**Comments (& Observations) on the Revision to the
“Project Description - Near Surface Disposal Facility at Chalk River Laboratories”
(Registry Number 80122)**

By W. Turner (Concerned Deep River Resident)

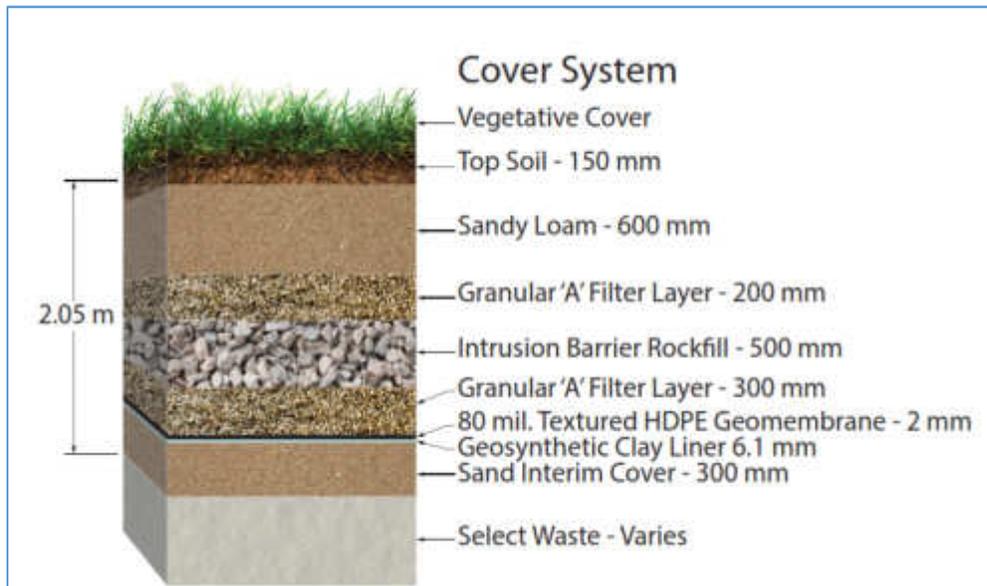
1.10 Inconsistencies between the Project Description and the NSDF Posters

From the Project Description the following is the figure depicting the cover.

From Poster 5, the following figure depicts the cover:

Although they may not be large, the discrepancies between the figures in the Project Description and those from Poster 5 are easy to find. It makes one wonder why the changes to the posters were not included in the revised Project Description. That said, easy to find inconsistencies such as these raises the question, “What other irregularities are there?” This leads to my next concern.
